Orderable: N/A	Designed for: Public Release	Mod. Date: 2/6/2015
TID #:	Project Title: TPS40170 Converter	
Number: PMP10799	Rev: B	Sheet Title:
SVN Rev: Version control disabled	Assembly Variant: [No Variations]	Sheet: 1 of 1
Drawn By:	File: PMP10799 REV B SchDoc	Size: B
Engineer: J Betten	Contact: http://www.ti.com/support	http://www.ti.com

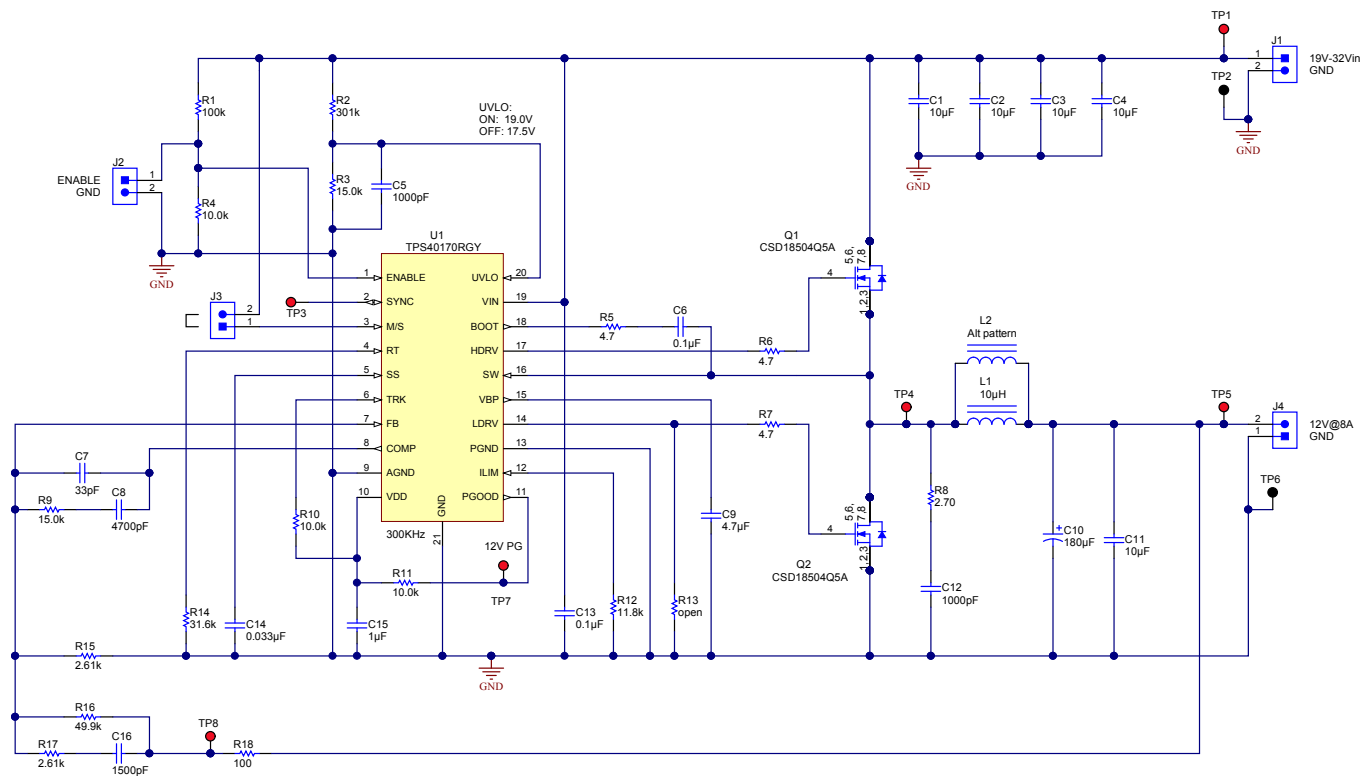
NOTES:
 1) REV B makes the following changes:
 L1 = XAL1510-103
 R12 = 11.8K
 Q1/Q2 = CSD18504Q5A
